NINEWA VILLAGE ROADS
SEGMENT 3
GOVERNORATE OF
NINEWA, IRAQ

SIGIR PA-06-035
APRIL 5, 2006

SUBJECT: Report on Project Assessment of Segment 3 of the Ninewa Village Roads in
the Governorate of Ninewa, Iraq (Report Number SIGIR-PA-06-035)

Diagram 1. Typical fill cross section

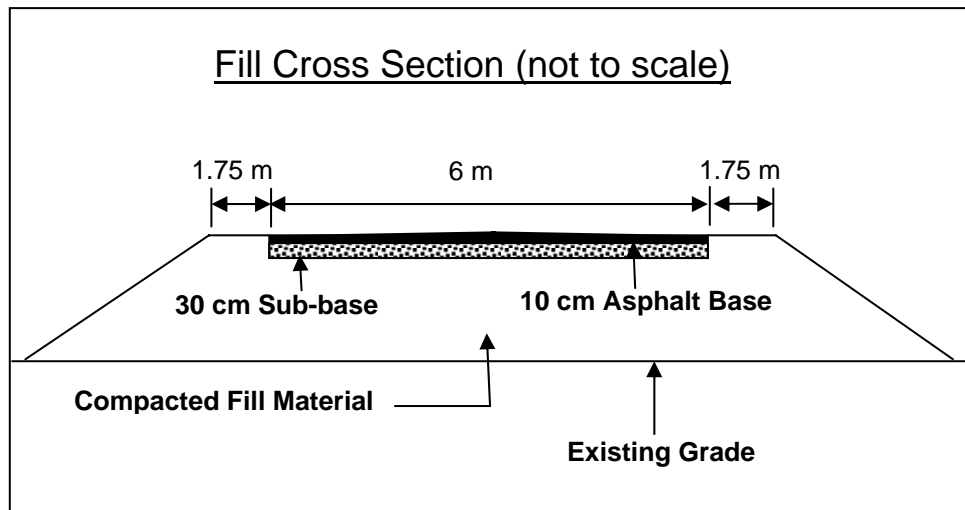
The contract BOQ included requirements for earthwork cut and fill sections. For fill sections, the contractor was required to clear and grub the natural ground to a depth of 10 cm and provide new suitable fill material compacted in layers of 20 cm to reach the profile contained in typical design cross section. For an illustration of a typical fill cross section, see Diagram 1.

Based on the review of the contract and our observations on site, the cut and fill sections appeared to meet the requirements of the contract.

Diagram 2. Typical cut cross section

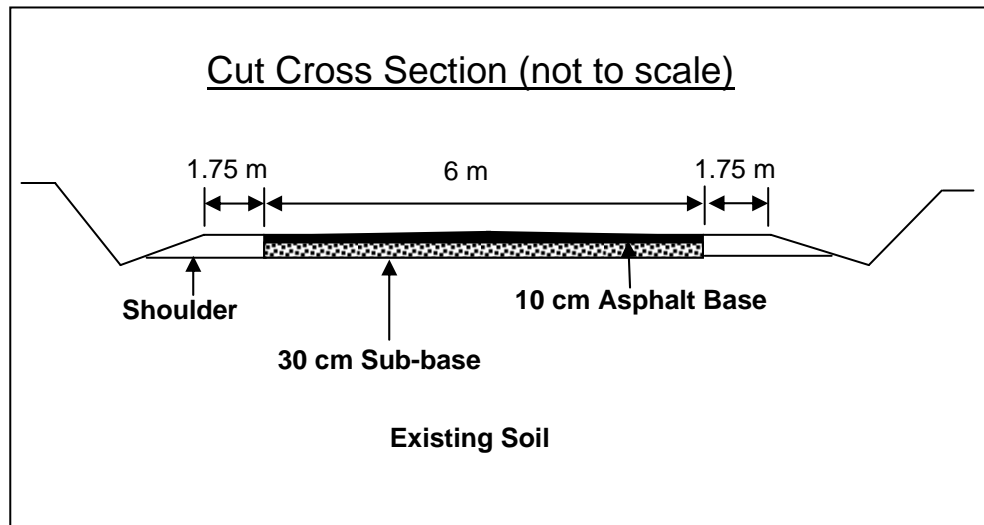
On a cut section, unneeded materials are removed so as to match the elevations provided in the design profile. Diagram 2 provides an illustration of a typical cut section.
